ACCESSION NBR:8205070203 DOC.DATE: 82/05/03 NOTARIZED: NO DOCKET #  
 FACIL:50-251 Turkey Point Plant, Unit 4, Florida Power and Light C 05000251  
 AUTH.NAME AUTHOR AFFILIATION  
 UHRIG,R.E. Florida Power & Light Co.  
 RECIP.NAME RECIPIENT AFFILIATION  
 VARGA,S.A. Operating Reactors Branch 1

SUBJECT: Responds to NRC 820316 ltr requesting addl info re  
 pressurized thermal shock.

Re: Turkey Point Unit 4  
Docket No. 50-251  
Pressurized Thermal Shock

Figure 1

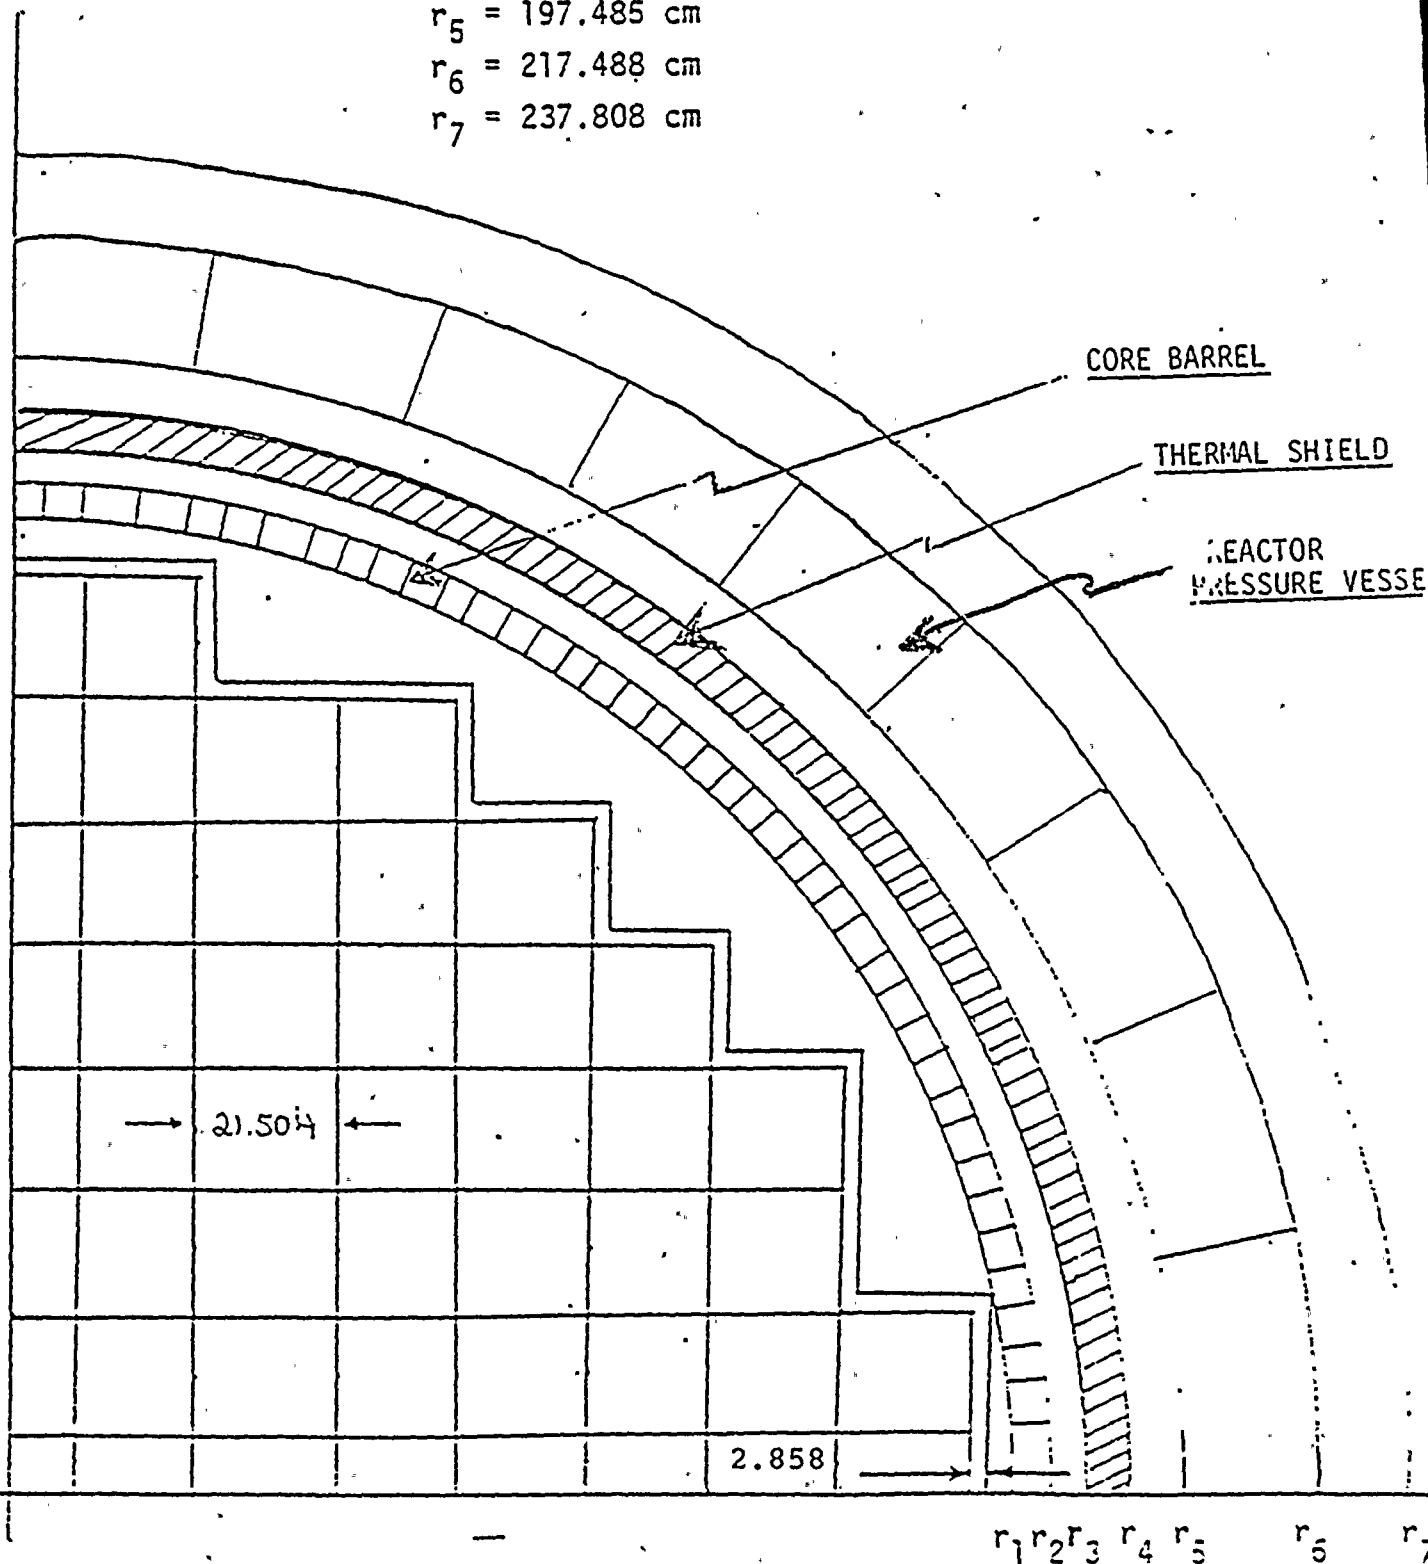
- (A) Plant specific information which would allow determination of the pressure vessel fluence. Such information should contain as built core and pressure vessel dimensions, regional material composition and neutron source for a two-dimensional (R-θ) and (R-Z) neutron transport solution, and

We have reviewed our as built drawings and reference documents . We conclude that the dimension shown on Figure Nos. 1, 2, and 3 represent the Turkey Point Unit No. 4 Vessel.

Specifically, the eccentricity of the inner radius of the reactor pressure vessel shown on Figure 1, is no greater than 0.05 cm (0.011 in.). The surveillance capsule slots are less than 1° from the dimension shown.

$r_1 = 170.021$  cm  
 $r_2 = 175.182$  cm  
 $r_3 = 181.134$  cm  
 $r_4 = 187.959$  cm  
 $r_5 = 197.485$  cm  
 $r_6 = 217.488$  cm  
 $r_7 = 237.808$  cm
